<div>Vendor</div> <div></div>	<div>ABT 360 KT/Y PP PLANT Project</div>		<div>Owner</div> <div><div>سراج گستران رجمال SERAJ GOSTARAN REJAL (سهامی خاص)</div></div>
	<div>Piping & Instrument Diagram (P&ID)</div>		
	<div>Vendor's Doc. No.: 23249-03</div>	<div>Rev.: 01</div>	
	<div>PPEC Doc. No.: L03-RE037-PR-PID-001</div>

PPEC REQ. NO. : L03-RE037-PR-PID-001

PROJECT : ABT 360 KT/Y PP PLANT Project				
TITLE :

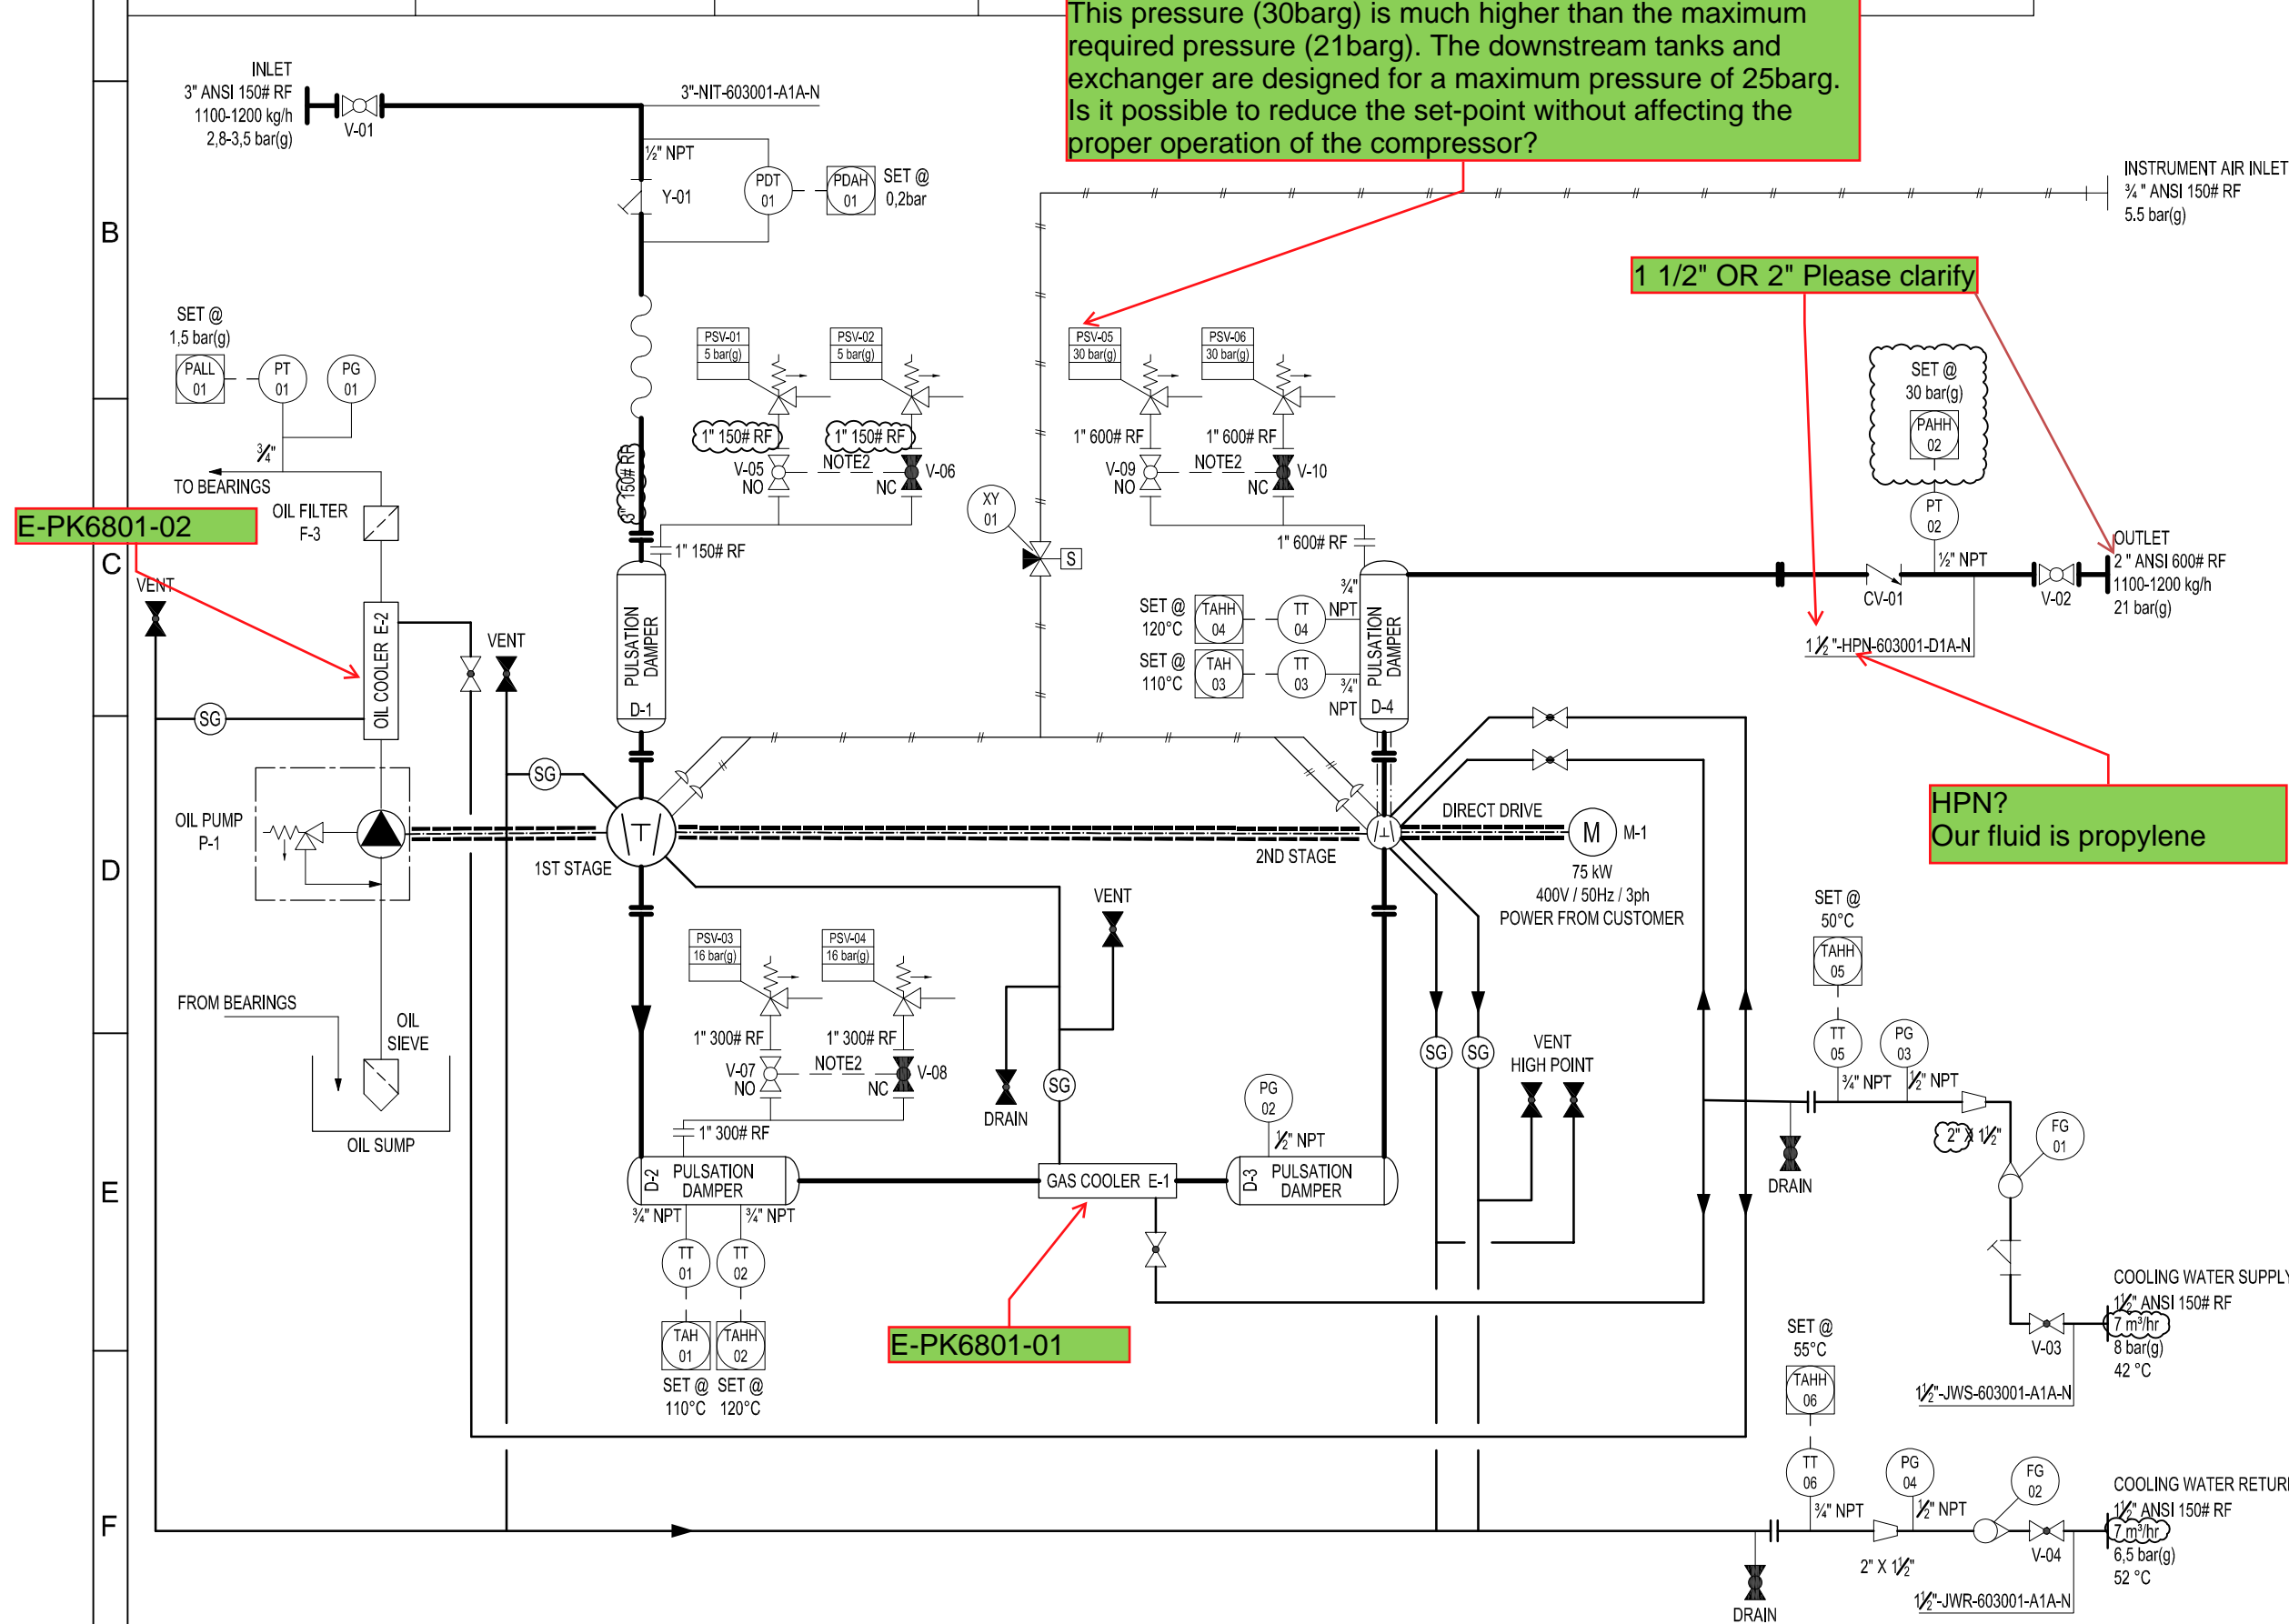
Our fluid is explosive so all vents and PSV's outlet should be collected and sent to the flare and also client It expects to give or take only one header from each fluid.
So you will receive one header of cooling water at the battery limit and we will only take one header delivered to the flare.
Provide the size of all the pipelines you need.
Please correct instrument and equipment tag number, I wrote some for example

This pressure (30barg) is much higher than the maximum required pressure (21barg). The downstream tanks and exchanger are designed for a maximum pressure of 25barg. Is it possible to reduce the set-point without affecting the proper operation of the compressor?
